Monkey tube

Profiles of tube r34c51 of Steam Generator 22

Figure 1 Profile of crack1 in tube R34C51 of steam generator 22.

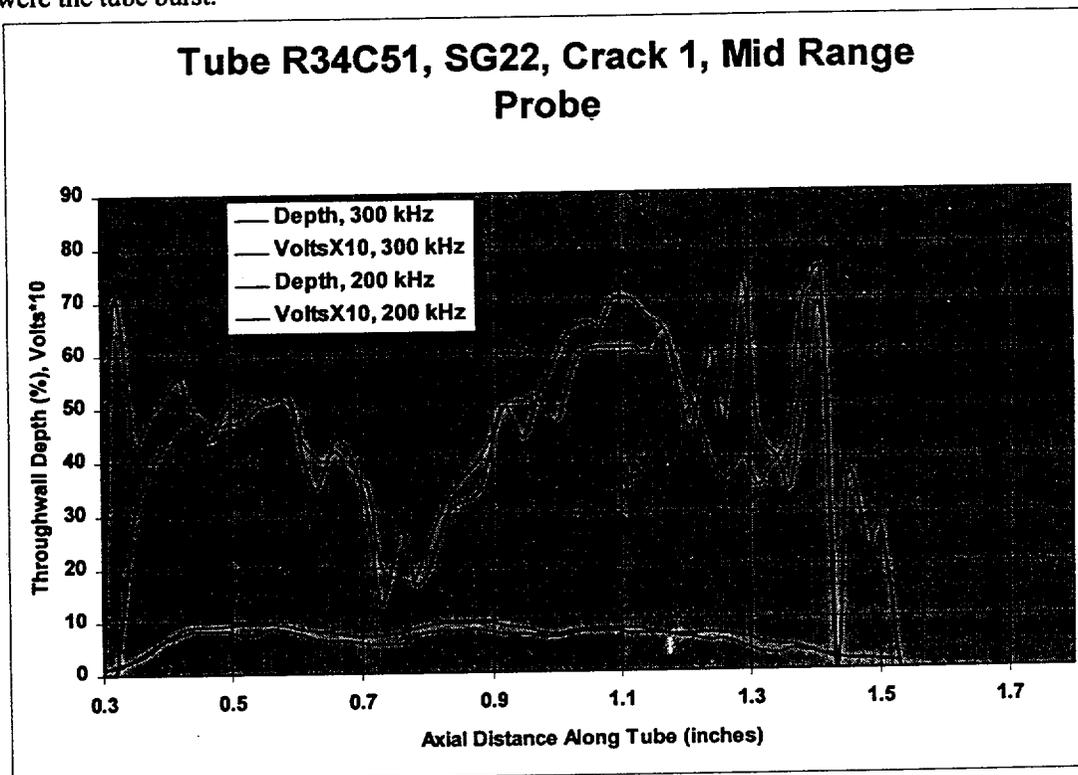
Tube r34c51 was profiled in the sludge region. This tube had two rather long cracks and two shorter cracks. All four were profiled, and are given in the figures below. All of the cracks were just above the tube sheet. The profiles were done using the 200 kHz and the 300 kHz test frequencies of the plus-point probe. Data were taken at 10 kHz, 100 kHz, 200 kHz and 300 kHz with both the plus point and the 0.115-inch diameter pancake coil. The 0.080-inch diameter high-frequency pancake coil was also used at 600 kHz and 300 kHz. The plus-point had the best signal-to-noise ratio for the tubes that I examined in the sludge pile region. The 0.080-inch diameter probe gave a sharp spike-like signal for the cracks. This coil may give better signal-to-noise at 800 kHz, where the noise should be rotated horizontal. Crack 1, as shown in Figure 1 was one of the larger ones, and had a voltage signal close to one volt. While this crack appeared to grow about 25% in voltage amplitude due to the pressurization, this is not the point where the tube burst.

Figure 2 Profile of crack 2 of tube r34c51 in steam generator 22.

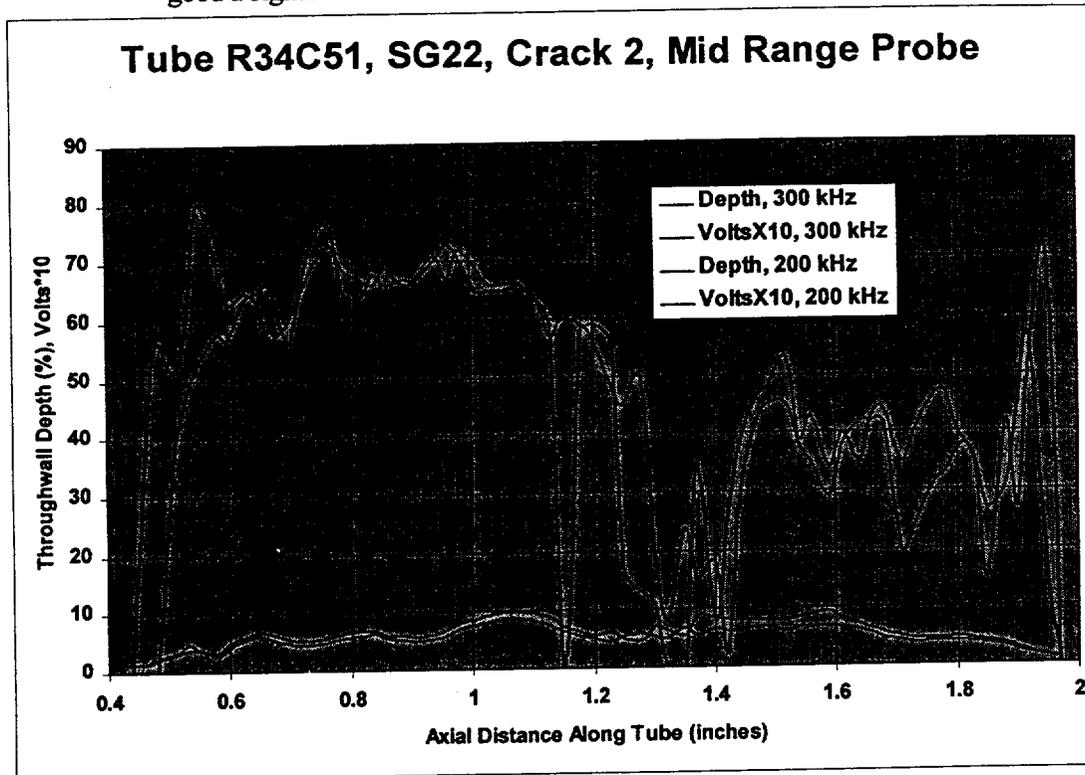
Crack 2, as shown in Figure 2, is slightly longer and slightly deeper. This is the crack that burst. The voltage amplitude of this crack is about the same, and probably averages less than that of crack one. This demonstrates that voltage is not a good measure of crack size, depth or severity. Crack 2 appeared to go through wall, and the voltage amplitude increased by a large factor. This tube also had a large voltage increase of a crevice crack due to the pressurization.

Figure 3 Profile of crack 3 in tube r34c51 of Steam Generator 22.

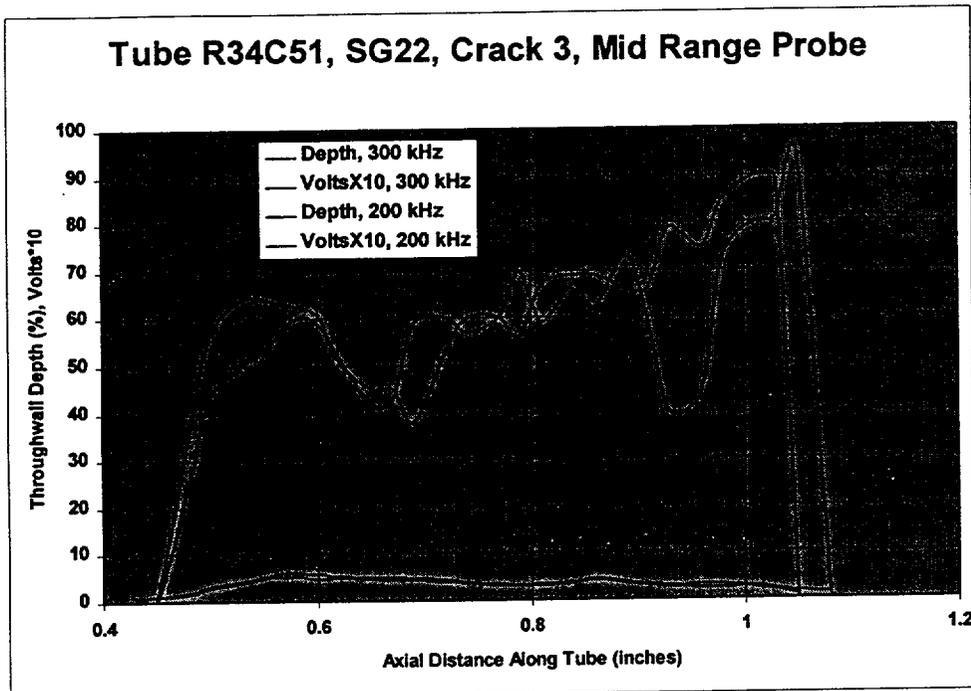
In Figure 3 and Figure 4 we show smaller cracks. In the post pressure-test scan these cracks

were still visible, but could not be profiled due to the large increase in signal from crack 2. Its signal distorted the phase of the smaller cracks, which were adjacent to it.

Figure 7 Effect of pressurization on Crack 1 for tube R34C51 of steam generator 22.

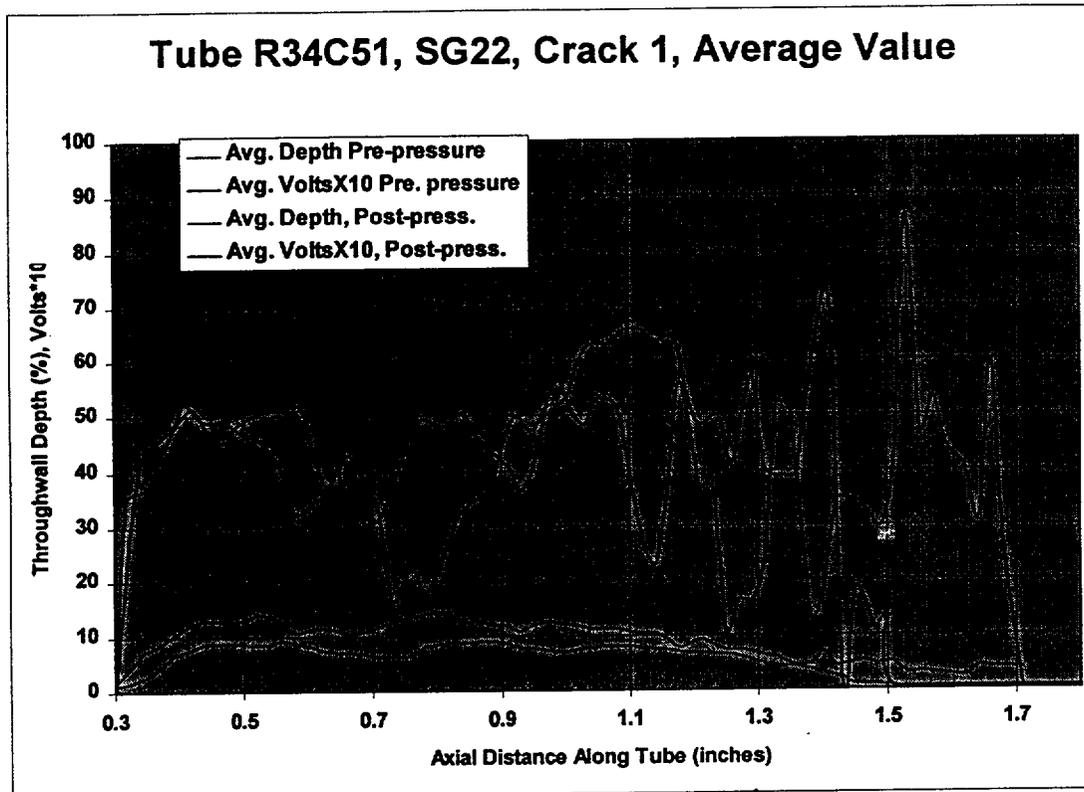
In Figure 7 we show the profiles averaged for the plus-point probe for the 300 kHz and the 200 kHz frequencies. The first part of the crack nearer the tube sheet seems to be about the same. For the second part of the crack, the readings seem to have become unreliable. The signals from all the coils were reviewed. The pancake coils showed a deeper crack, but there also was evidence of increased lift-off. The crack may have spread apart somewhat, due to the pressure test, and is no longer strictly crack shaped. The amplitude of the signal increased for all of the coils. This increase was about 25% for most of the crack for the plus-point coils. There probably would have been more increase if Crack 2 had not opened up, relieving the stress.

Measurements made on this crack with the 0.080-inch high frequency probe showed a very sharp spike-like response before pressurization, and a more broad response afterwards, also indicating some spreading of the crack. A comparison of Crack1 in figures 5 and 6 show that the base of the crack is much fatter as the distance from the tube sheet has increased. Another crack parallel to Crack1 may have opened in this region, causing errors in the depth readings.

Figure 8 Effects of pressurization on Crack 2 in tube R34C51 of Steam Generator 22.

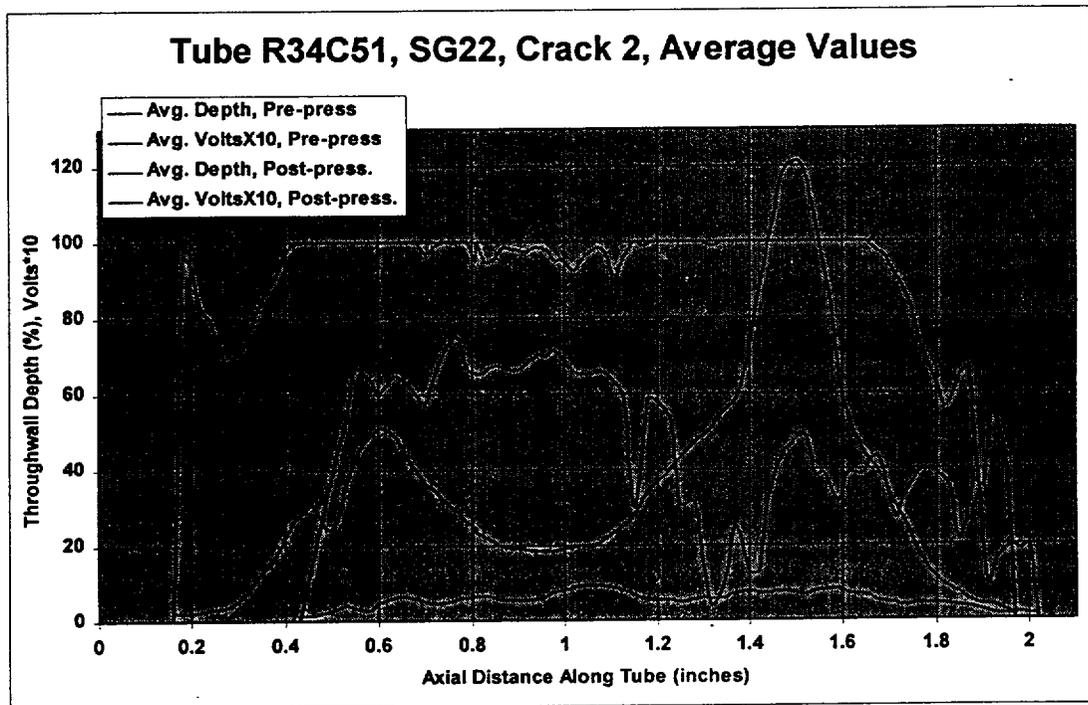
In Figure 8 we show the profiles for Crack 2, for the plus-point probe, averaged over the 300 kHz and the 200 kHz frequencies. These readings appear to be more regular, but they were also

considerably distorted. This crack reading switched from od to id a number of places along the length, and the crack signal was not the classic shape that occurs on the calibration standards. When the signal went to id, the crack was assigned a value of 100%.

The amplitude of this crack signal increased to 12 volts. The amplitude calibration was set for a 100% EDM notch to have a voltage of 20-volts. Even a through wall crack must have some current bridging across the crack face to cause the signal to decrease to this value.
